**Pass Christian
Site Demolition and Site Work**

00.901 ADDENDUM NO. 1
(This Addendum contains 2 pages, 4 attachments (8-1/2"x11"))

1 REVISED SITE FENCING PLAN
 AD1-A1 SCALE : 1"=100'

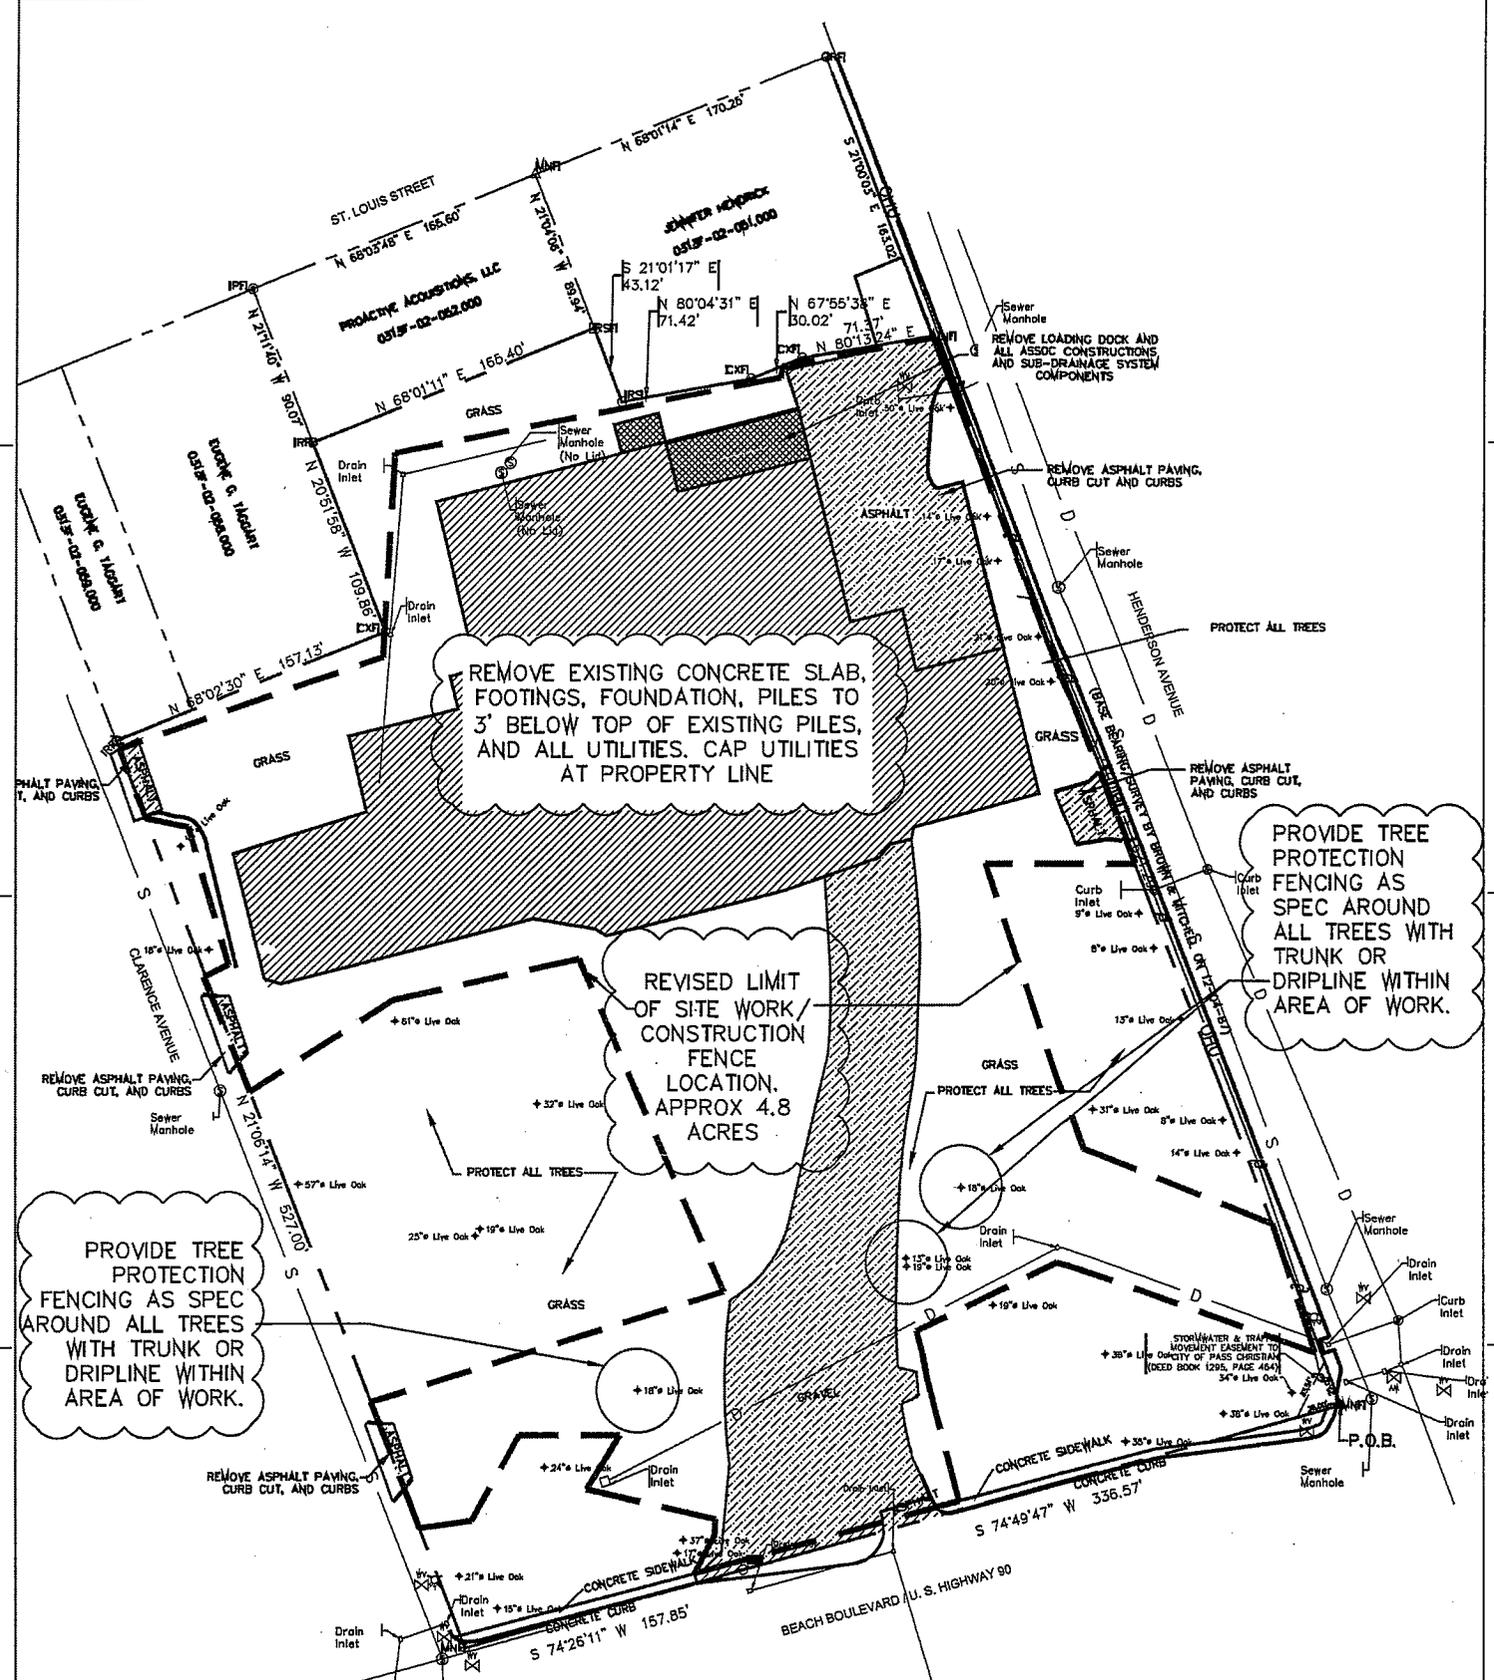
3. Sheet A-1:
- a. Revise 1/A-1 per attached AD1-A1 to show revised limits of site fencing and revised note for removal of pile.
4. Sheet A-2:
- a. Under Site Work Notes, revise note 4 to read, "Contractor shall provide topsoil and hydroseed over area of work (as delineated by temporary construction site fencing) only. See Sheet AD1-A1 for temporary construction site fencing."

REMOVE EXISTING CONCRETE SLAB, FOOTINGS, FOUNDATION, PILES TO 3' BELOW TOP OF EXISTING PILES, AND ALL UTILITIES. CAP UTILITIES AT PROPERTY LINE

REVISED LIMIT OF SITE WORK/ CONSTRUCTION FENCE LOCATION, APPROX 4.8 ACRES

PROVIDE TREE PROTECTION FENCING AS SPEC AROUND ALL TREES WITH TRUNK OR DRIPLINE WITHIN AREA OF WORK.
